Addendum #2

June 25, 2026

Lindsay Wellness Center

Pool Deck Renovation Project

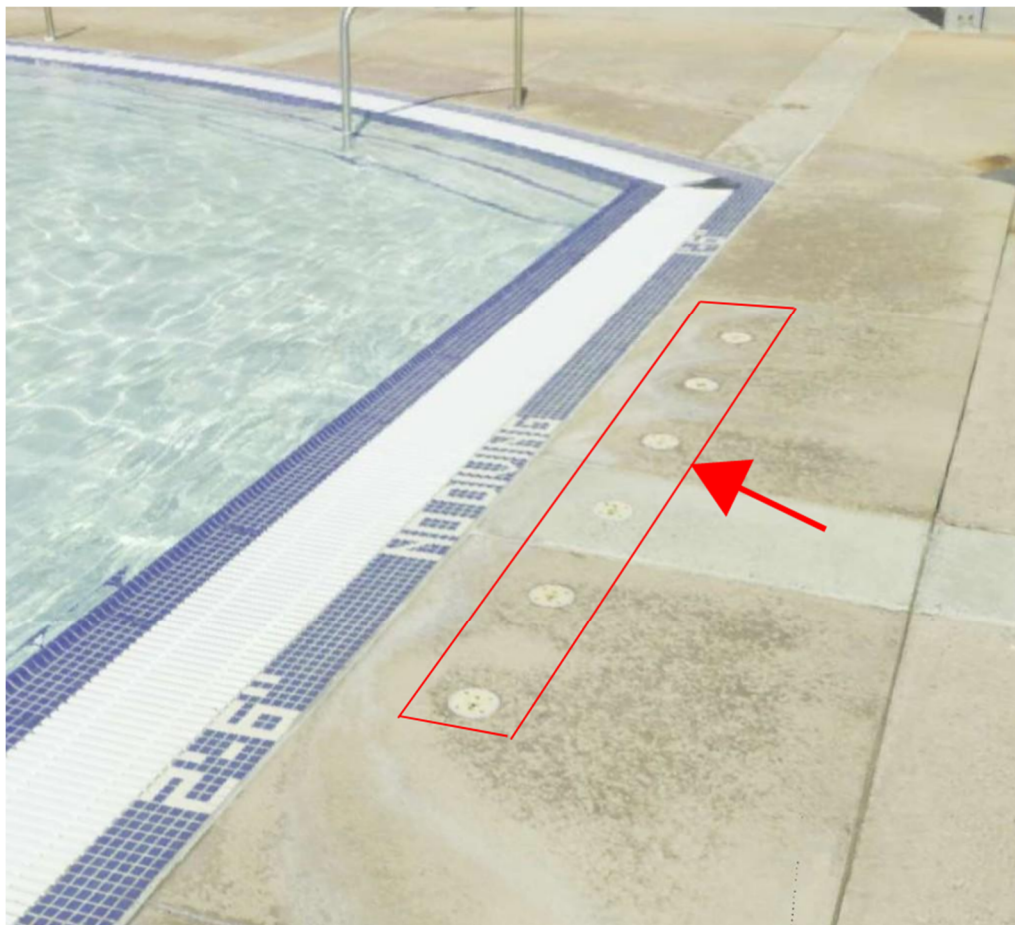
Q: On the Part Description List on Sheet BP-002 item #6 May or May not be needed should verify on bid walk. As the jobwalk was not mandatory, and we were unable to attend, was this verified? Please advise if we are including.

A: Please include.
